From: Jesse Gagliano
Sent: Sunday, March 07, 2010 3:32 PM
To: Hafle, Mark E
Cc: Morel, Brian P; Cocalles, Brett W
Subject: RE: Macondo 11-7/8 or 11-3/4 Expandable
Attachments: image005.jpg; image006.jpg; image007.jpg; image008.jpg

Subject: Macondo 11-7/8 or 11-3/4 Expandable

11 7/8" Liner set at 16000' @ Previous Shoe

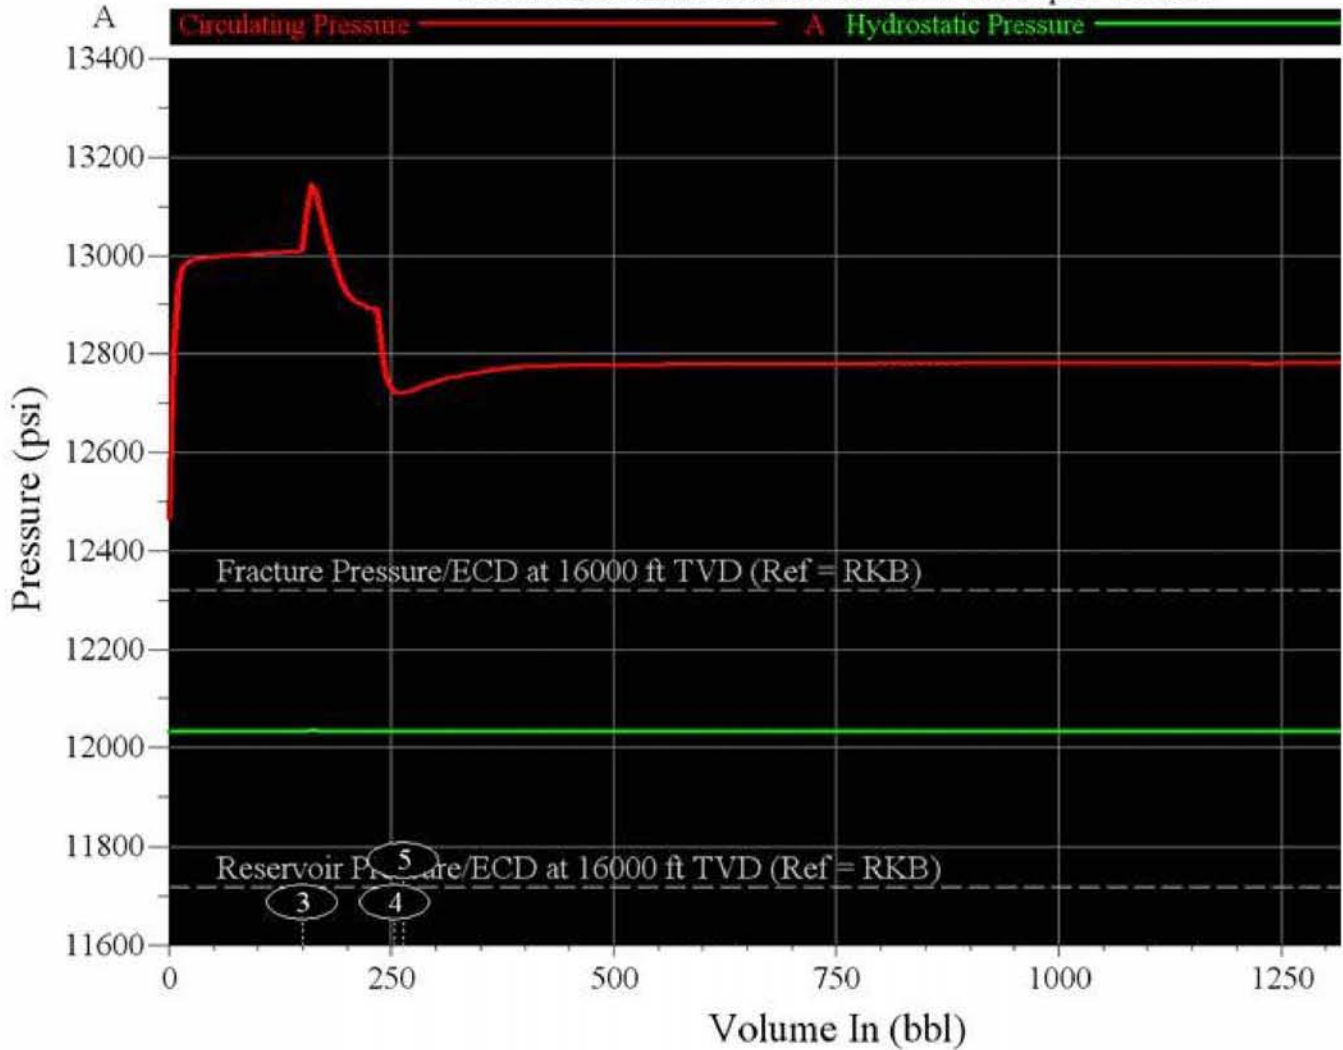
Below are the ECD graphs for both options. For the 11 7/8" Liner option we can set it to 16000' and get cement lift for the Production casing. The more we push it past 16000', the more it will break down the shoe. We will not have return though because we will break down the previous shoe. For the expandable Liner we can set it at 17000' and get good cement lift. The previous shoe looks good as well with this option. If we push the expandable further then there is minimal effect to the ECD. If we set it shallow the ECD look good at TD, but the shallower we set the expandable the more likely we will break down the previous shoe and not get returns.
